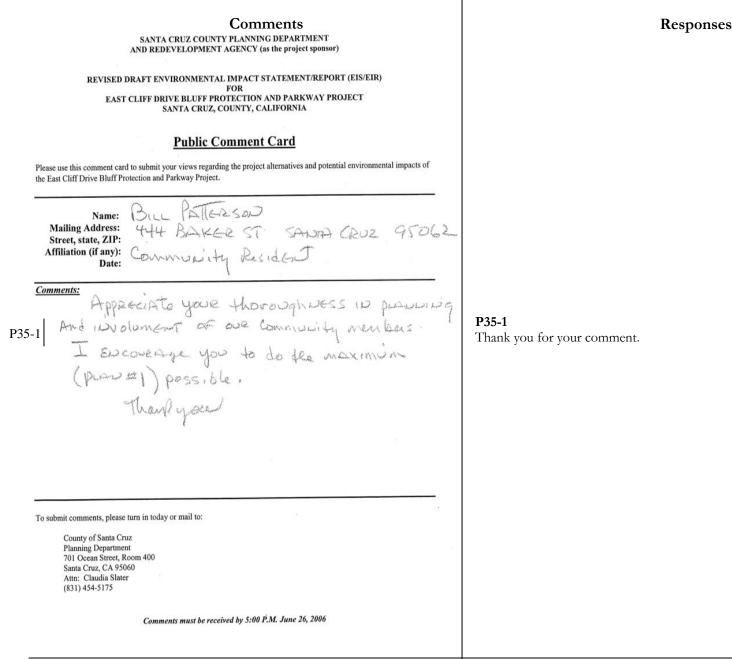
At the west end (32nd Avenue) of the reverse one-way the east bound traffic on East Cliff Drive could reverse its direction and either do a u-turn and return east on East Cliff Drive; or turn left on 32nd Avenue; or turn right on Pleasure Point Drive.

The reverse one-way would give direct access to the beach from 41st Avenue (the main artery towards the beach), improve traffic flow, waiting time, exhaust pollution, dangerous traffic situations and flow of gas money to some of the countries that are involved in terrorism. Just the safety improvement alone mandates serious consideration of this proposal. If traffic continues in the present direction it is just a matter of time before a pedestrian is killed by a driver looking back over their right shoulder at surf conditions. If the traffic were reversed, deaths could be prevented.

As discussed in Section 2.4.2 of the Revised Final EIS/EIR, East Cliff Drive between 32nd and 41st avenues was converted to oneway operation in 1994. No particular safety problems associated with the eastbound traffic direction have occurred since that time. While traffic reversal along East Cliff Drive would allow easier ocean viewing, it would also alter traffic patterns in the area. A reversal of the one-way traffic would be counter to the prevailing west to east traffic pattern. Consequently, most motorists would continue to travel through the area in an easterly direction and would be required to use Portola Drive as a detour, then loop around through the residential neighborhood to East Cliff Drive. Traffic levels would increase on 30th Avenue, as motorists detoured to Portola Avenue, and would increase on 36th, 37th, and 38th avenues as motorists cut through to access East Cliff Drive. The expected traffic volume on 38th Avenue would be approximately 1,800 vehicles per day, which is normally considered the maximum desirable traffic volume for a residential street. The expected traffic volume on 30th Avenue would be about 3,000 vehicles per day. For these reasons, the project proposal does not include reversing the flow of traffic on East Cliff Drive.
